Re: Questions by Email.

FCC ID: H9PNP3010  
Date: April 16, 1999

Re: FCC ID H9PND3010  
Applicant: Symbol Technologies Inc  
Correspondence Reference Number: 7793  
731 Confirmation Number: EA93911  
Date of Original E-Mail: 05/14/1999

## Attachment A

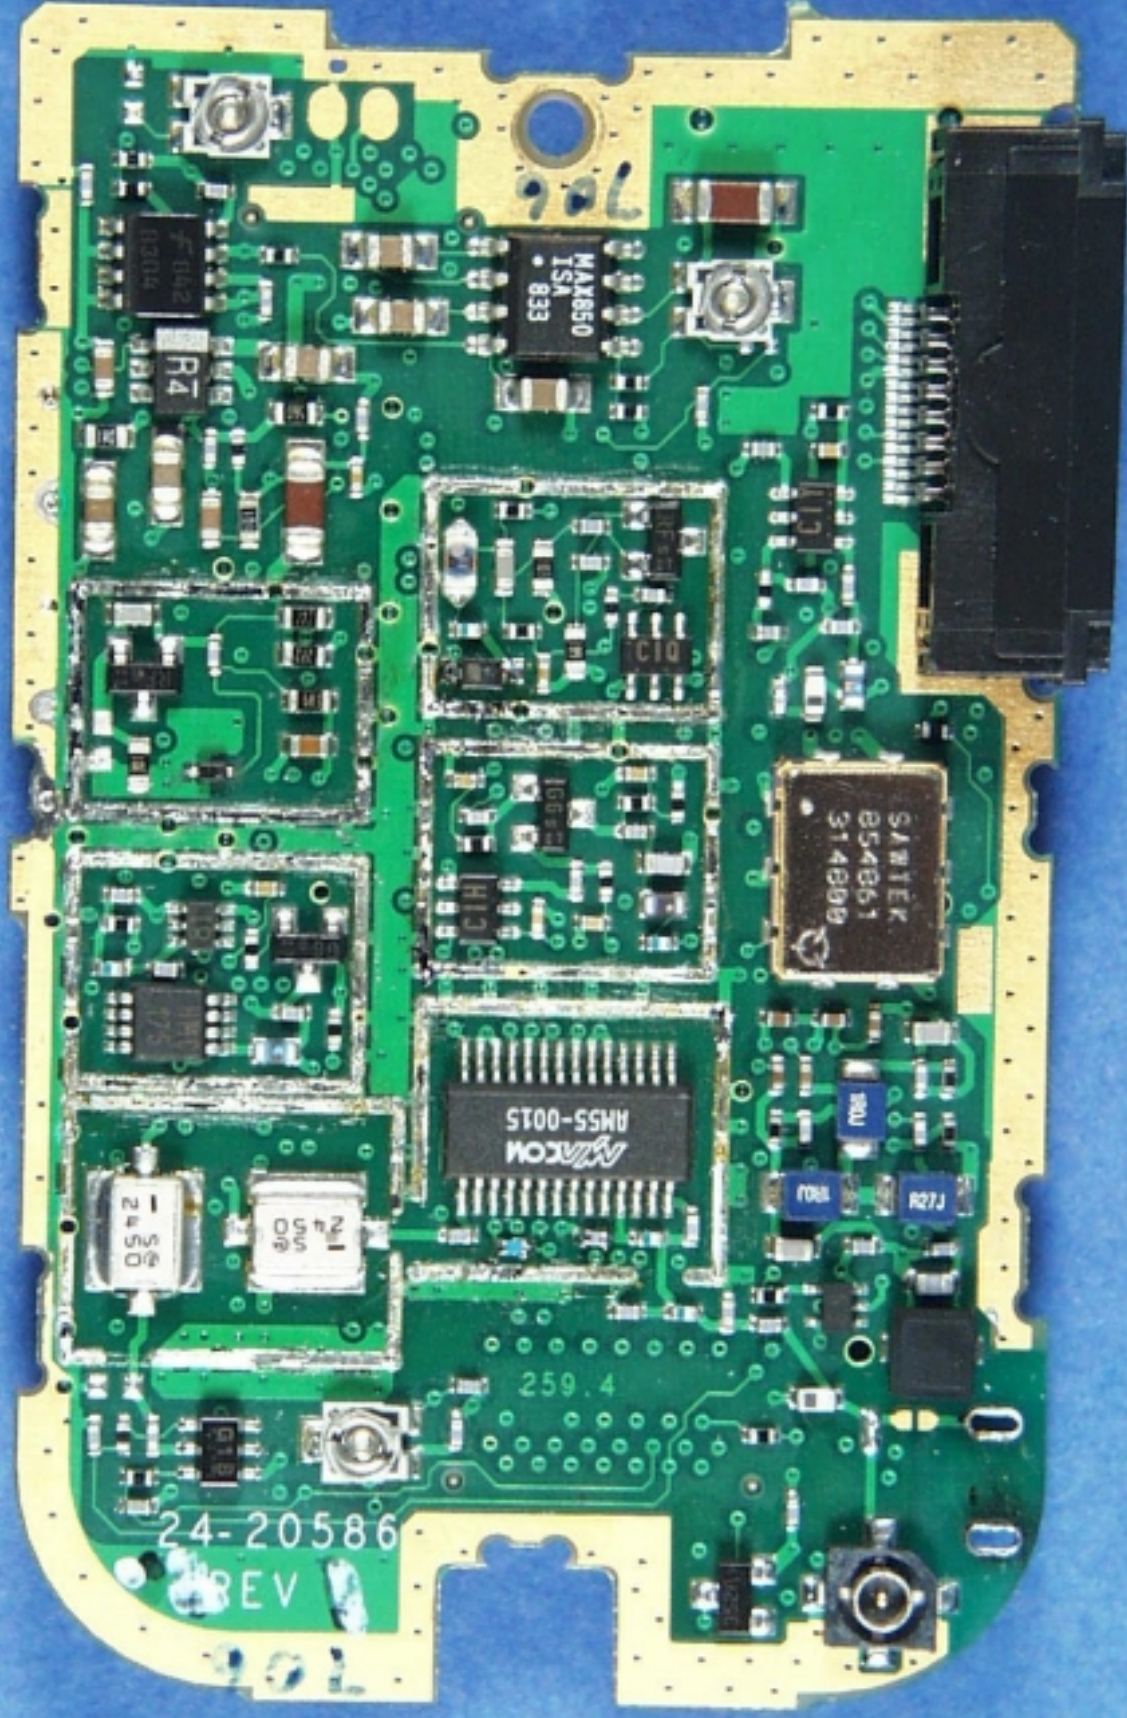
*2) The photo's of both sides of the RF board contain too many shields. Please provide photo's without the shields.*

Please see Attachment A.

## Attachment B

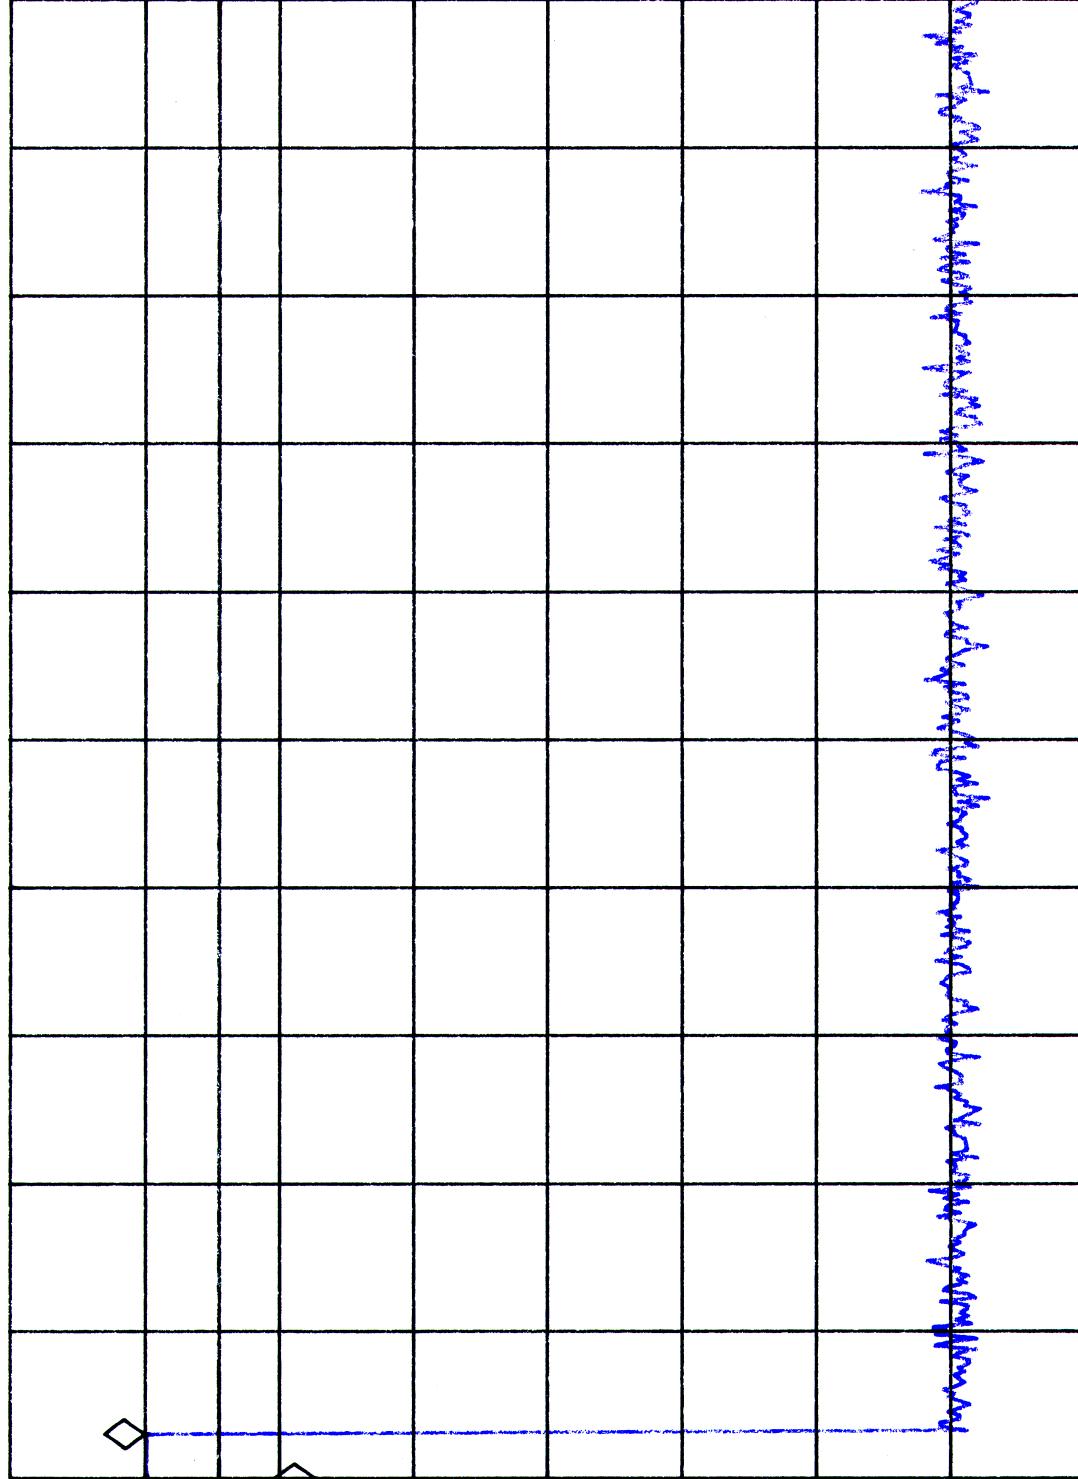
*4) With regard to the radiate emission test data, a duty cycle factor of 10 dB was used. However, the dwell time was 100 msec. Since the duty cycle is the on time per 100 msec, the duty cycle should have been 0 dB. Please explain/correct accordingly.*

Unfortunately the emissions test software was running on the DUT when the dwell plot was taken. Attachment B explains the duty cycle with the operational software loaded and contains the correct dwell plot.

The communications from the NetVision Phone to the Access Point begins with the NetVision Phone listening (in receive mode, transmitter off) to determine if any other transmission is under way the listening takes place for at least 0.1 msec. The NetVision Phone then transmits a maximum packet size of 32 bytes of voice data, with addressing and other packet overhead the packet size is 112 bytes at 1 Mbit per second the packet time is  $112 \text{ bytes} \times 8 \text{ bits/byte} / 1 \text{ Mbitsec} = 0.896 \text{ msec}$ . The Access Point replies with an acknowledgment in 0.02 msec the acknowledgment packet is 0.2 msec long and during the acknowledgment packet the NetVision Phone is in receive mode (transmitter is off). The NetVision Phone typically sends one packet every 30 msec but can send a maximum of 12 packets in any 100 msec interval. Therefore the NetVision Phone transmit duty cycle is:

Maximum transmit time in 100 msec interval  $\leq (12 \text{ packets}) (0.896 \text{ msec/packet})$

Maximum transmit time in 100 msec interval = 10.75 msec.

Duty Cycle  $\leq$  Maximum NetVision Phone transmit time / 100 msec

Duty Cycle  $< 10.75 \%$

The correction factor is then  $20 \log (.1075) = 19.37 \text{ dB}$ .
